**DRAINAGE LETTER  
FOR  
STERLING RANCH ROAD  
CROSSING OF SAND CREEK**

Job No. 1183.11

PCD Project No. CDR-226

# STERLING RANCH ROAD CROSSING (BridgeCor Steel Box 38'-1" x 11'-11")

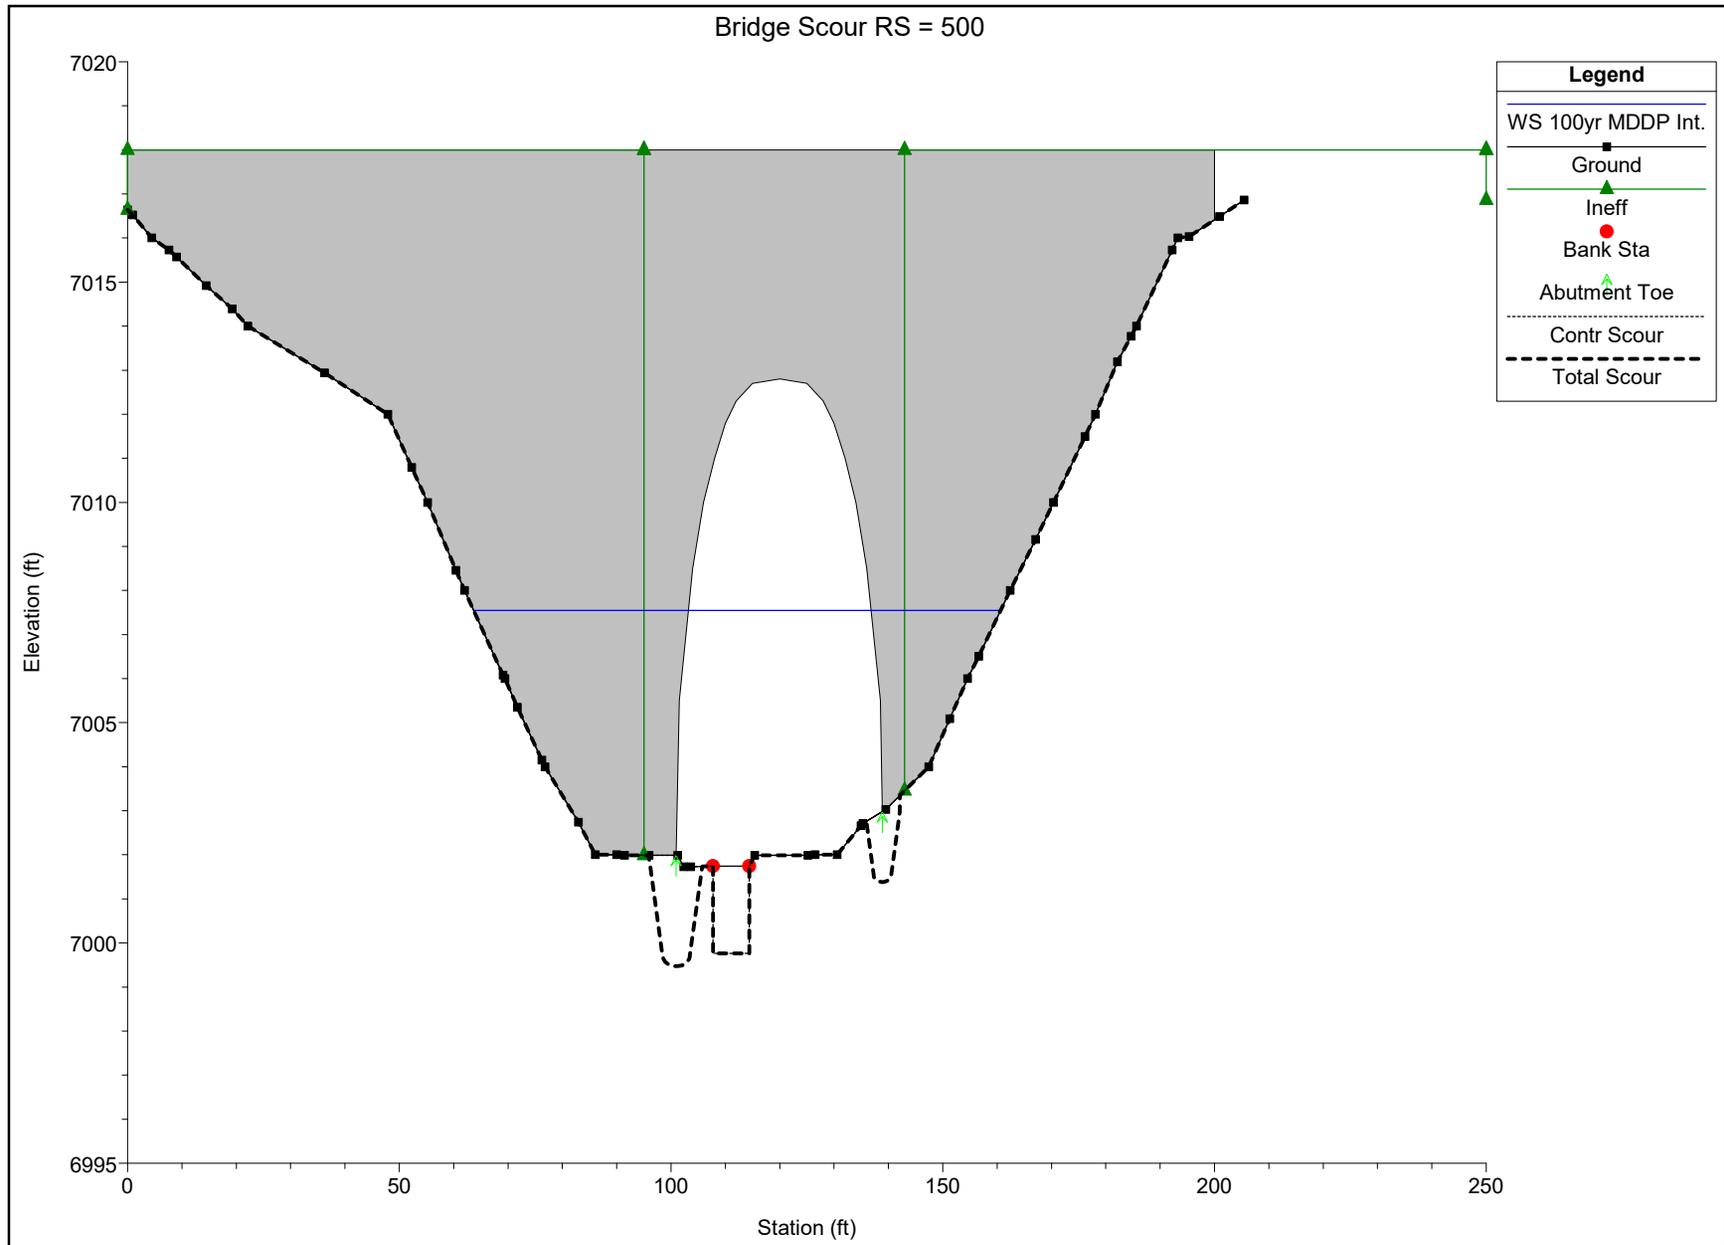
provide 500-year and worst-case also
